HL 1-26 & DDR 1-26

April 23, 2026, Historic Landmarks Committee (HLC) Meeting

DDR 1-26

Construct a new four-story apartment building on a mixed-use site with a continued church use.

DDR 1-26 (Proposed Building)

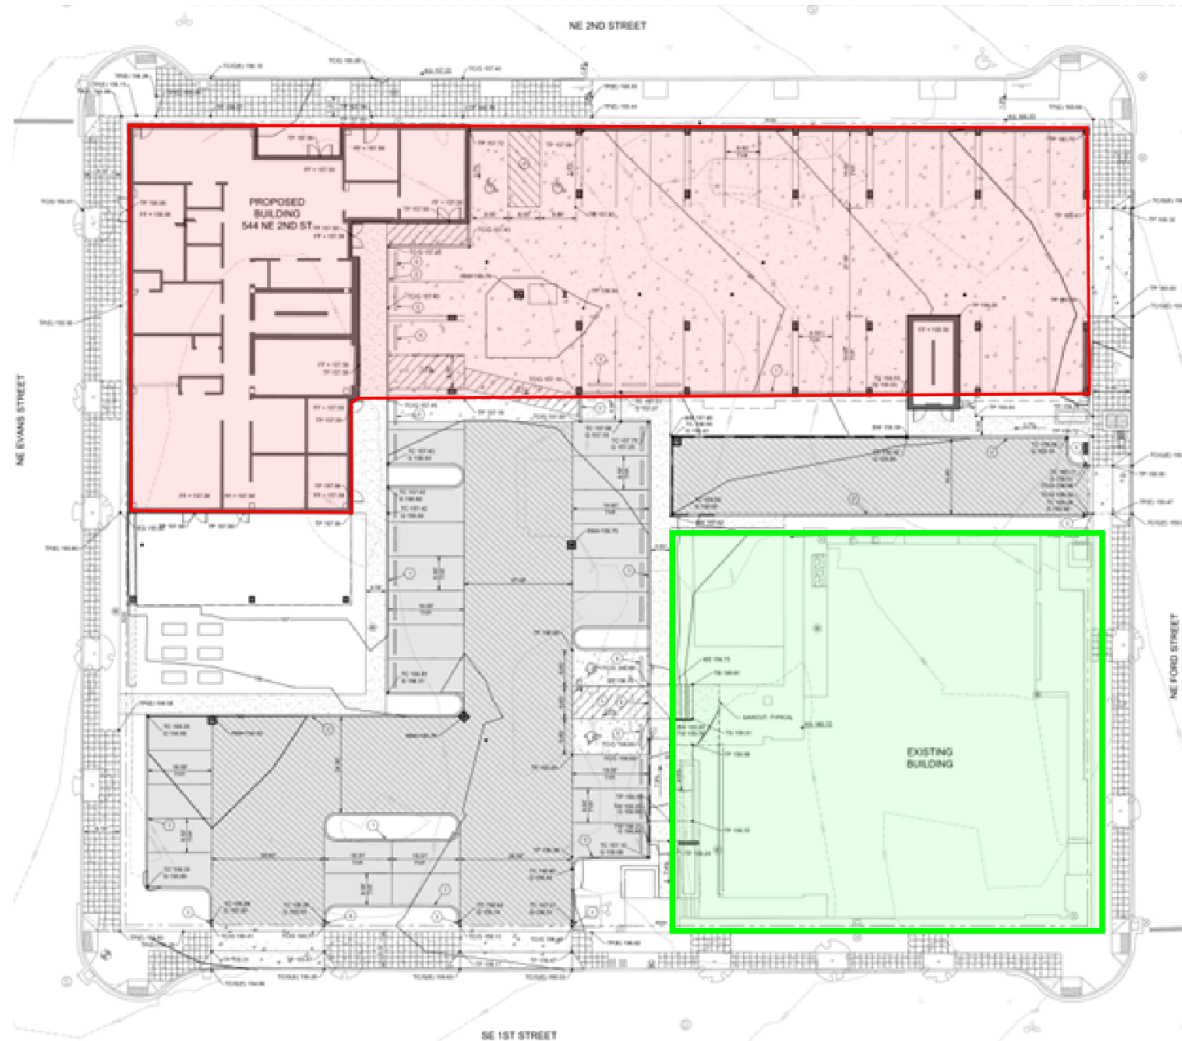
Updated Design from April 9

Updated Design
from April 9
